SCOSTA CORP.

WOOD, STEEL OR TIMBER
ROOF & FLOOR TRUSSES

SCALE: 1/4"=1'-0"	DATE: 01/20/22	REVISED BY:	DRAWN BY: KCD
JOB ADDRESS: SOLUNA 6 UNIT		1 OF 1	
CUSTOMER: D.R. HORTON		JOB #: DRSOLU6

SCALE: 1/4"=1'-0"	DATE: 01/20/22	REVISED BY: KCD	DRAWN BY: KCD
JOB ADDRESS: SOLUNA 6 UNIT FLRS			1 OF 1
CUSTOMER: D.R. HORTON		JOB #: DRSOLU6F

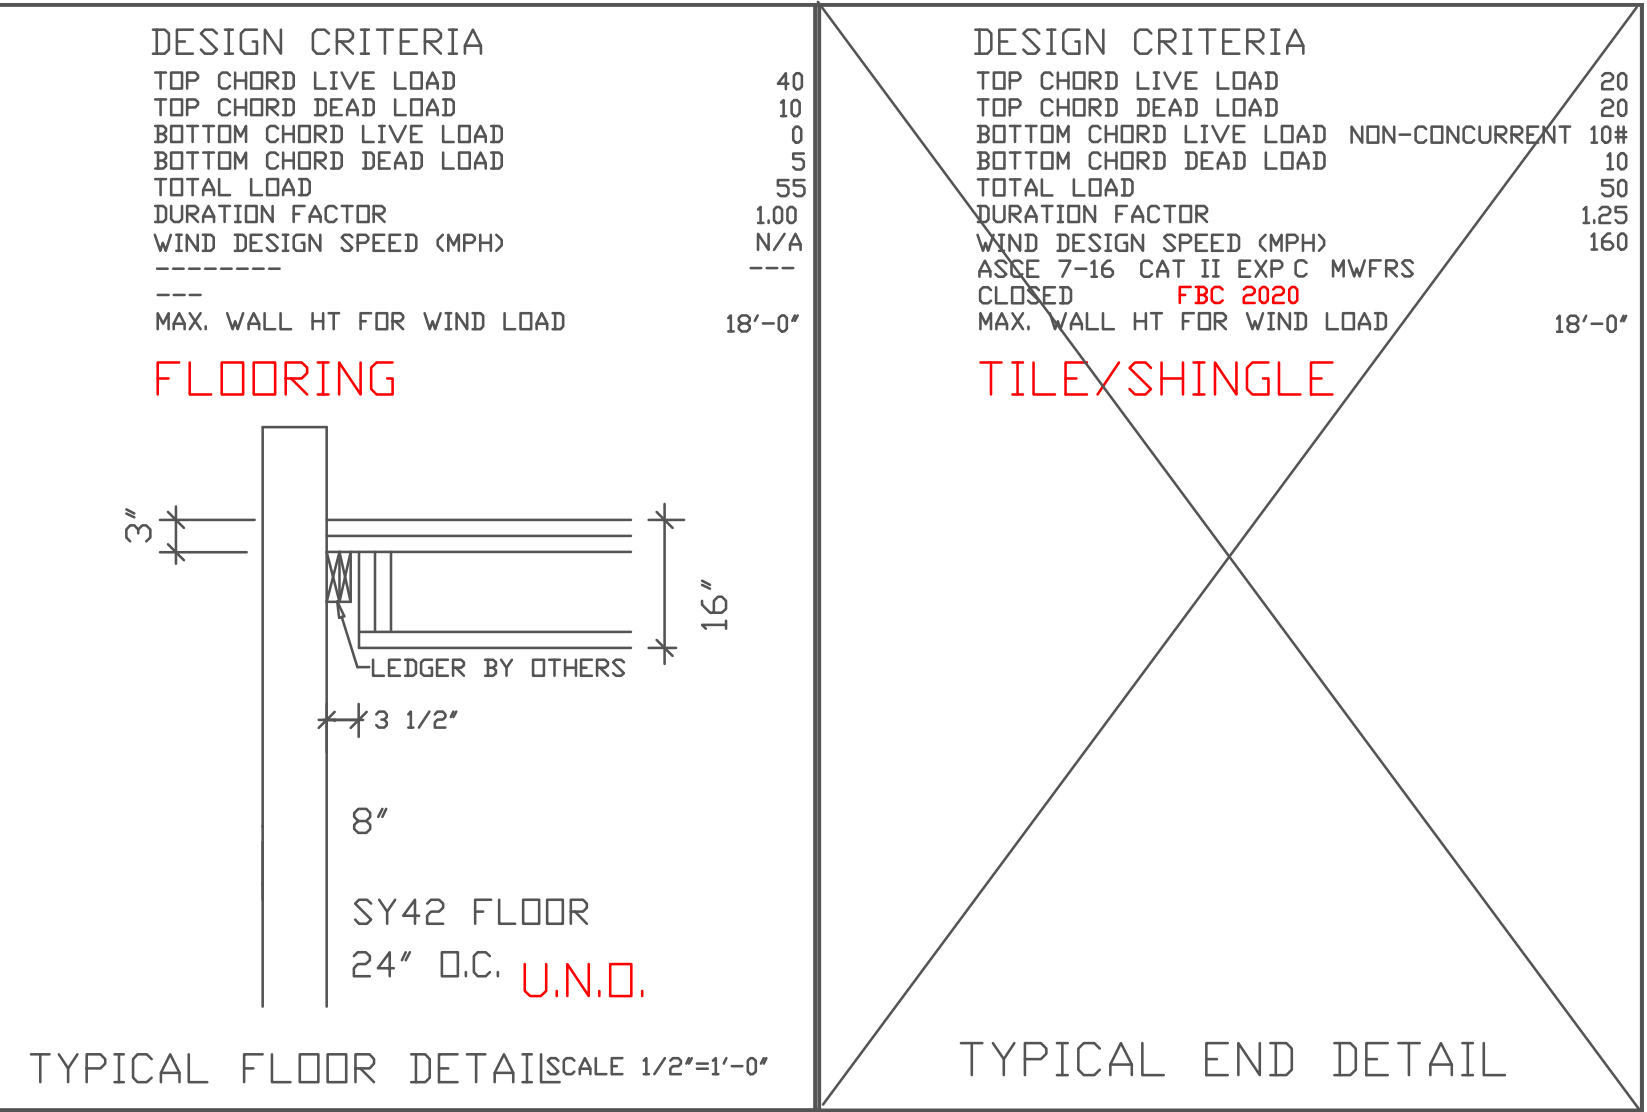
This document has been reviewed for
conformance with the design intent of the
structure and specified design criteria.

☒ Accepted As-Is ☐ Accepted As Noted ☐ Revise and Resubmit

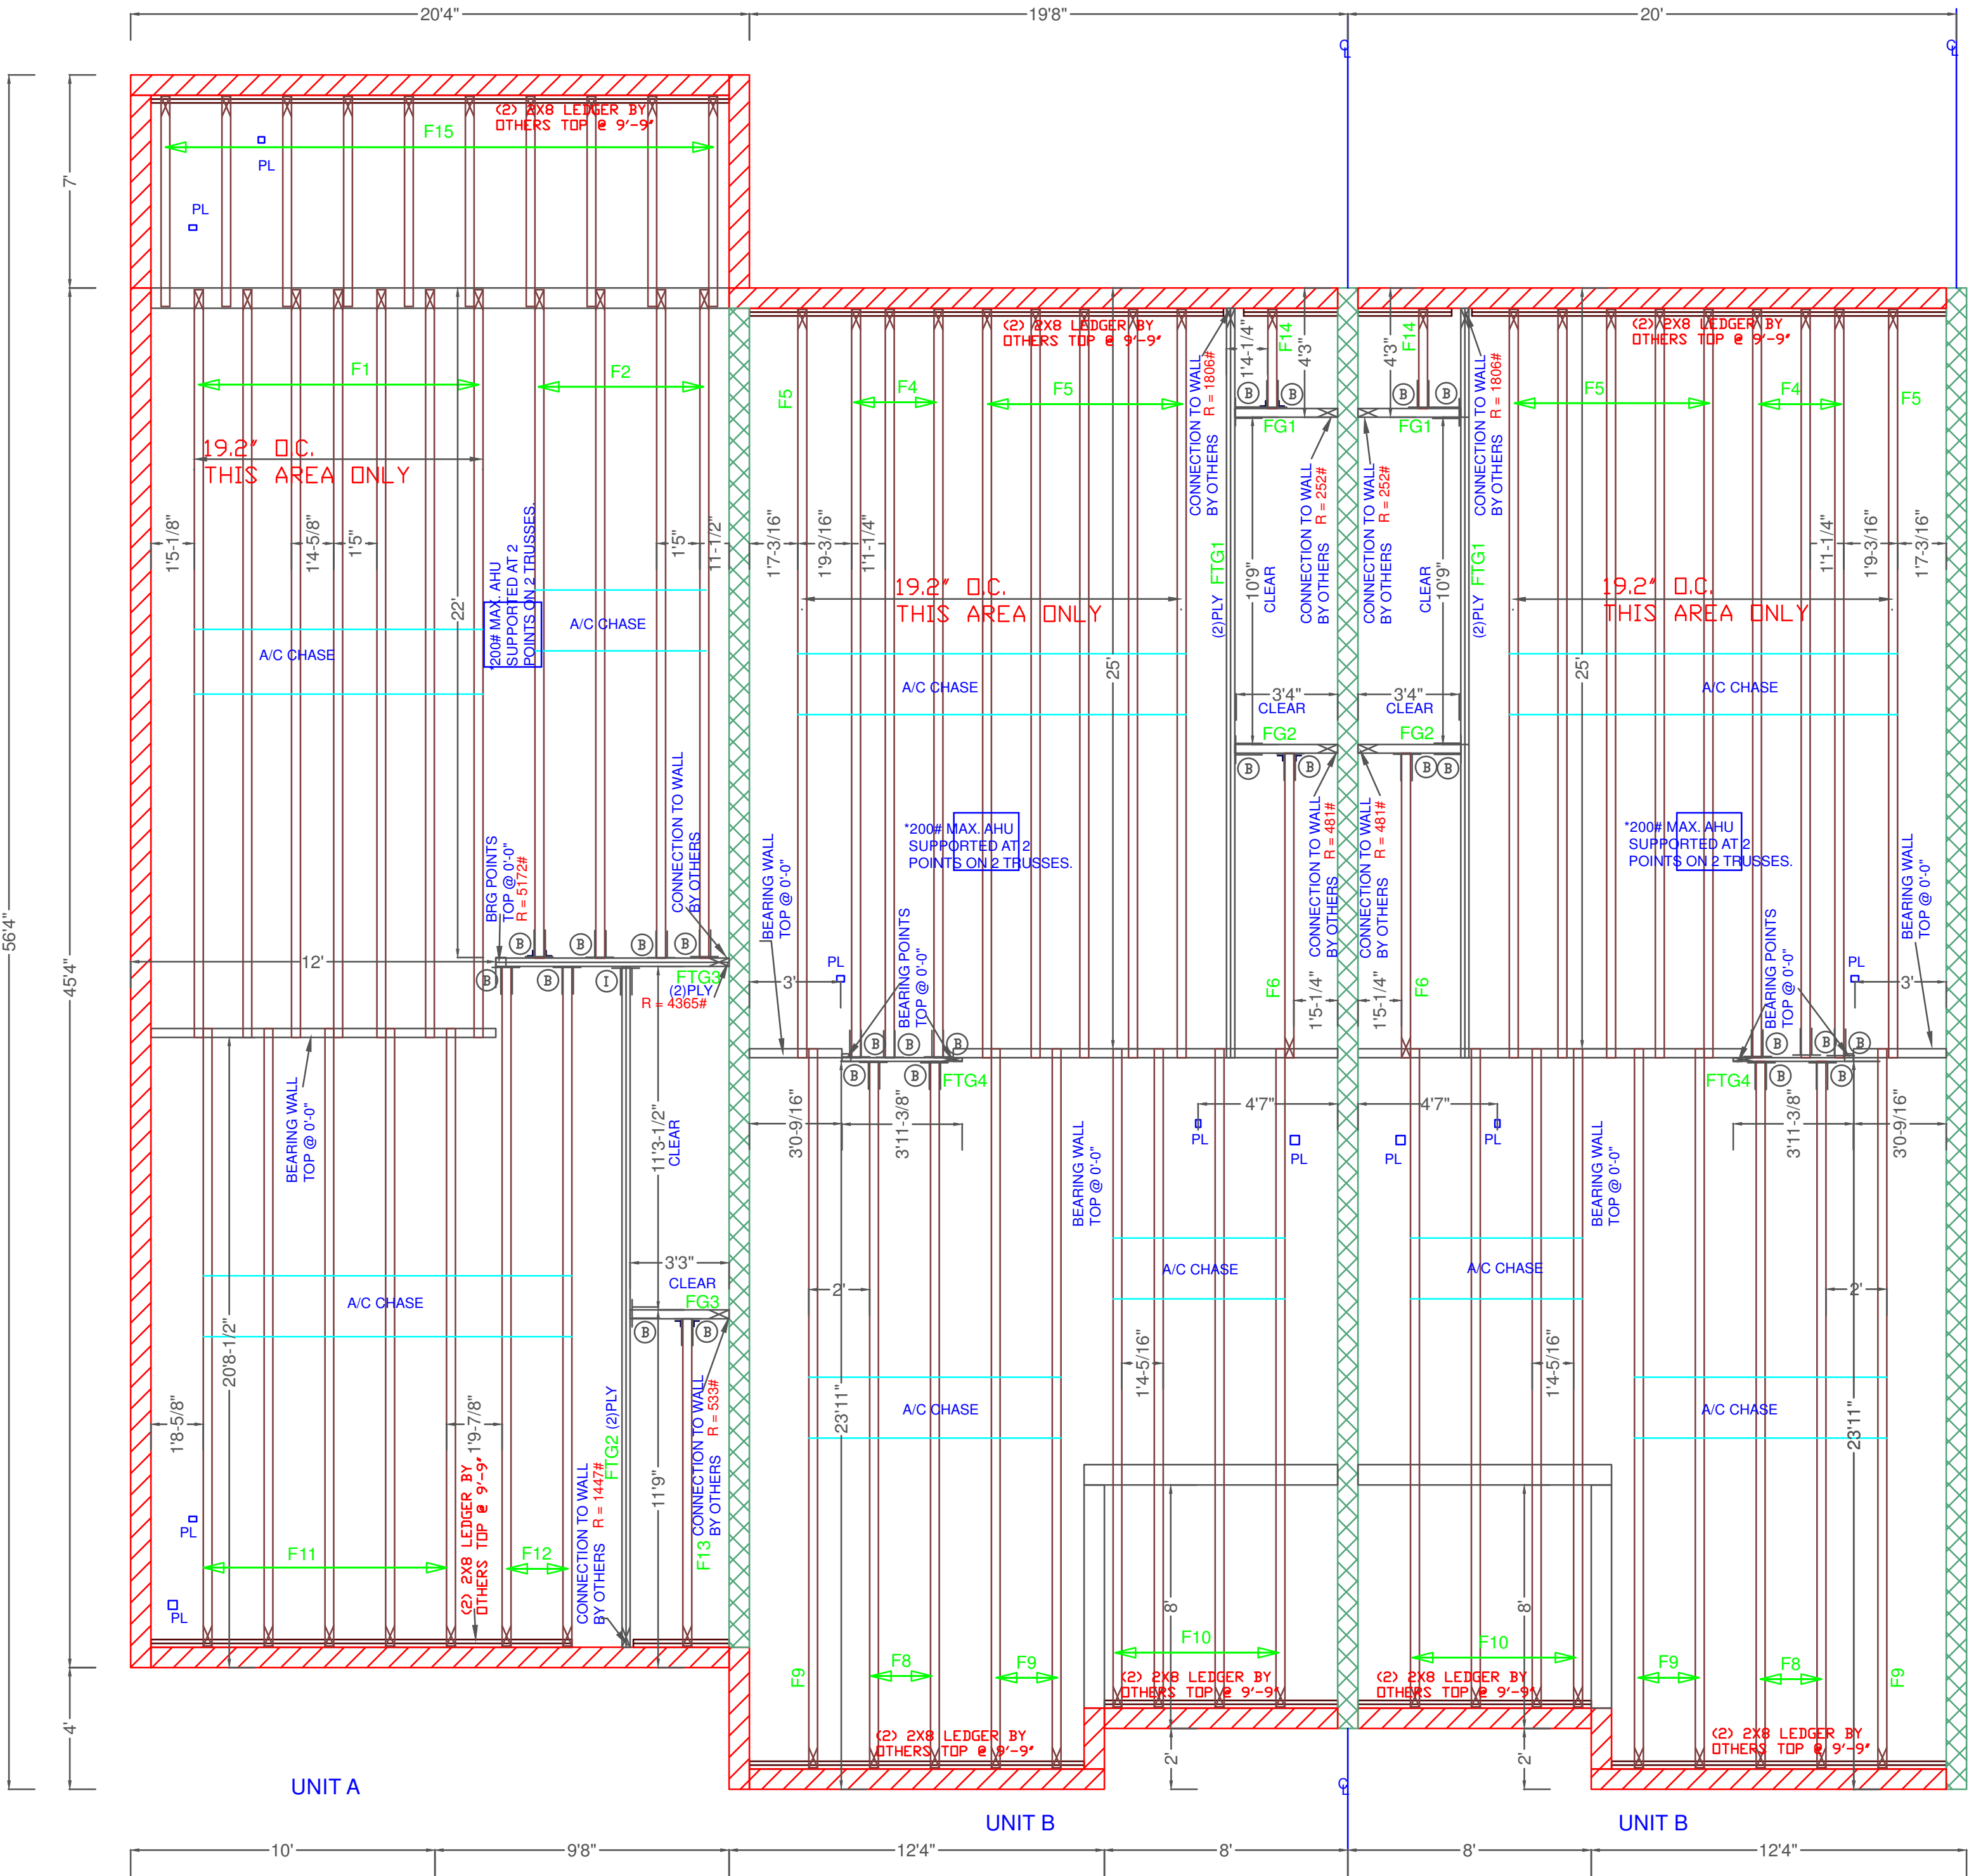
This document has been reviewed for
conformance with the design intent of the
structure and specified design criteria.

☒ Accepted As-Is ☐ Accepted As Noted ☐ Revise and Resubmit
